# **Electrical Energy & Safety Audit Report of Kharupetia College, Kharupetia, Darrang, Assam**

**Audit Period:** 21/03/2023 – 01/04/2023

**Audited by:** MONADITYA

### Observed safety weaknesses of the transformer substation:

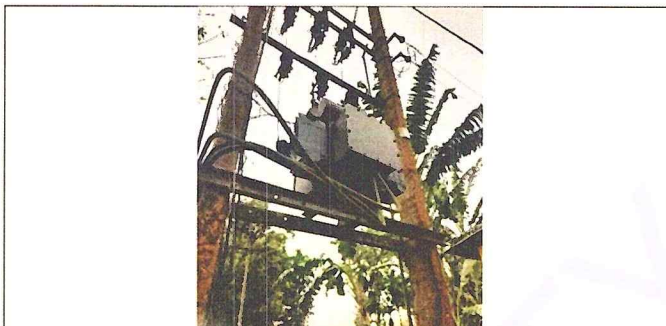
Sl. No.	Observation	Photo
1.	The transformer substation area was found to be fully covered by weeds and creepers. During the audit, the substation area was partially cleaned up under our direction.	
2.	The DO fuses for the transformer have been replaced by simple wires and have no barrels.	
3.	One of the three Line type lighting arresters is missing.

Sl. No.	Observation	Photo
4.	<p>The naked GI wire drawn from the Line Type LAs to its earth-pit is touching the GI channels mounted on the PSC DP structure. The transformer and other substation accessories are all mounted on this structure. In the event of a lightning strike, there is a possibility of this naked wire energizing the mounting channels and equipment mounted on this DP structure with high voltage lightning strikes.</p> <p>This GI wire should be replaced by a 11 or 33KV insulated 1 core 75sq.mm Cu or Al cable to avoid such a hazard.</p>

5.	There are no cable glands / gland plate installed for the LT cables outgoing from the transformer's Power Receiving Panel (PRP).	
6.	<p><b>Earthing:</b></p> <ul style="list-style-type: none"> <li>• The earth-pits for the substation equipment's earthing have been buried under concrete cover and are untraceable.</li> <li>• There is no earthing provided for the transformer's PRP.</li> </ul>

#### Observation:

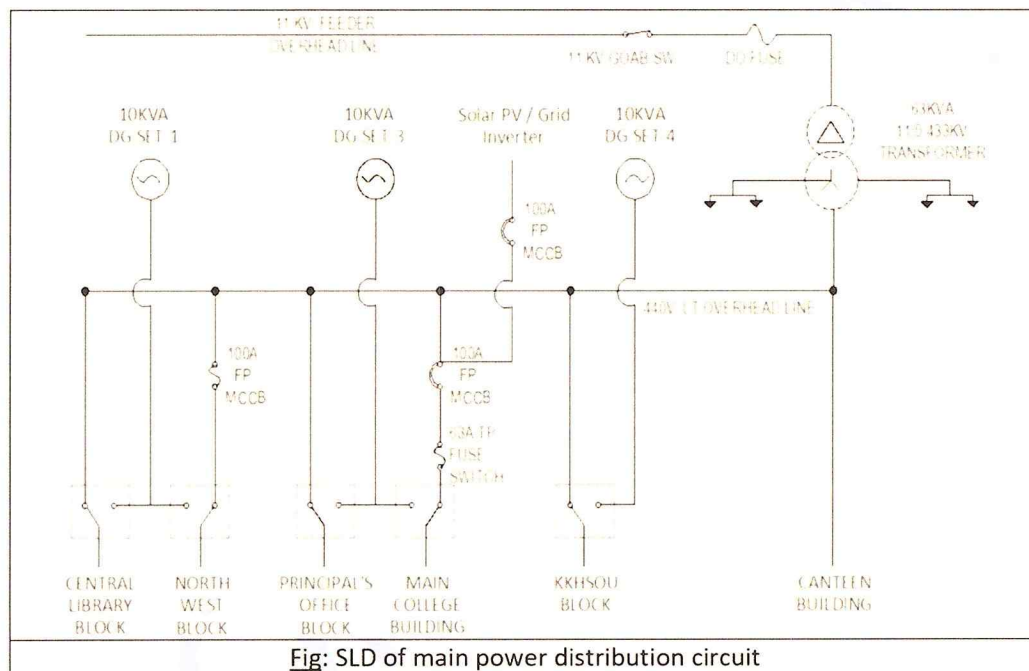
One of the three solar panels in the solar array set-2 was found to be damaged. Since the solar panels are connected in series, this entire solar array set has been disconnected. Currently, only 25KWp (from the solar array set-1) out of total capacity of 40KWp of the solar plant is being generated.

This damaged solar panel should be repaired at the earliest so that the entire solar power capacity of the solar plant can be utilized.

**Fig: Average Voltage Profile – Grid supply**

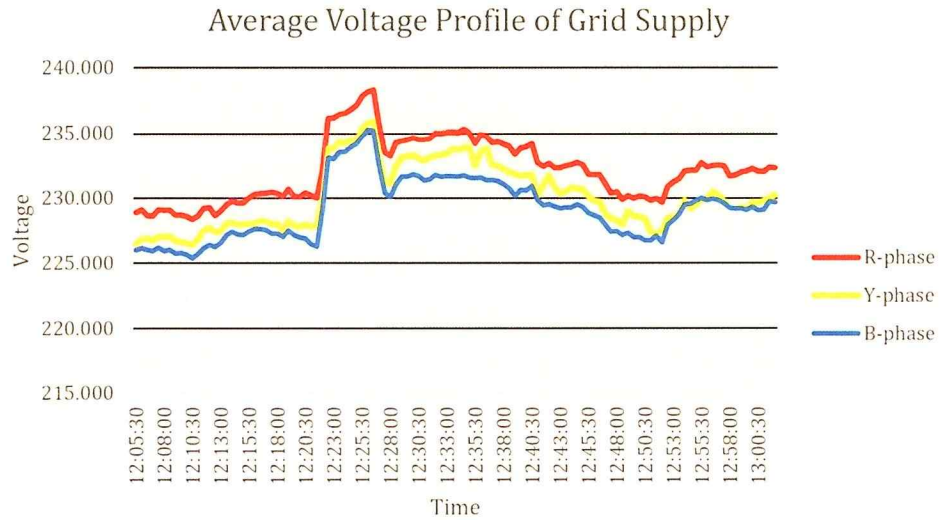
The average voltage of the Grid Supply as can be seen in the graph above is 230.49V (L-N). The voltage variation was found to be within 225.36 to 238.3 V.

Photo: Earth-pit for DG-3's Neutral earthing.

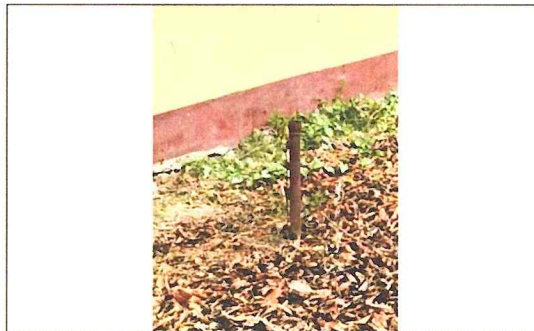
- The DG set-4 has one earth-pit for its Neutral earthing. The DG's neutral is connected through 8 SWG GI wires to a 40mm dia. GI earth-pipe.
- This earth-pit does not have any protection chamber, hinged cover or watering funnel.
- The earth-pit(s) for DG set-4 (if any) could not be traced out during the audit.

**Photos:** Earth-pit constructed near the Principal's office

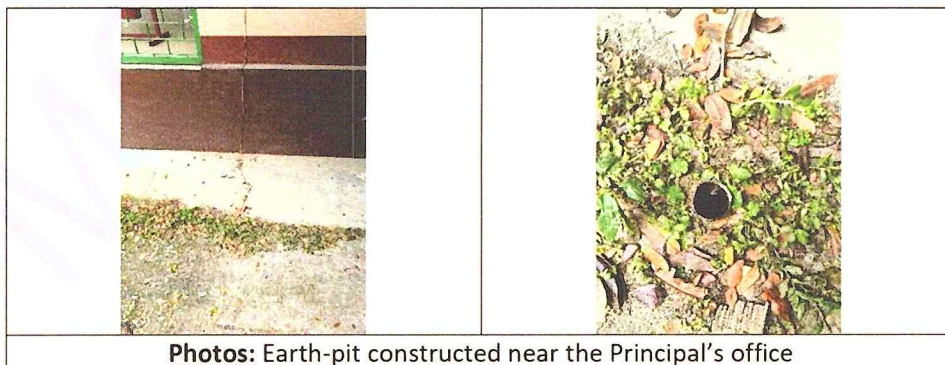
- Earthing connection to the switchboards at the Principal's Office block, Central Library block and Main College Building is provided through 1.5 sq.mm. copper wires. These copper wires are connected to a 40mm dia. GI earth-pipe buried near the Principal's office.
- This earth-pit does not have any protection chamber, hinged cover or watering funnel.
- The earth resistance value measured at this earth-pit was found to be extremely high (>100 Ohms).

A complete revamping of the earth arrangement is necessary.

New earth-pits should be constructed for providing earthing to the switchboard circuits. These earth-pits should be placed at easily accessible locations.
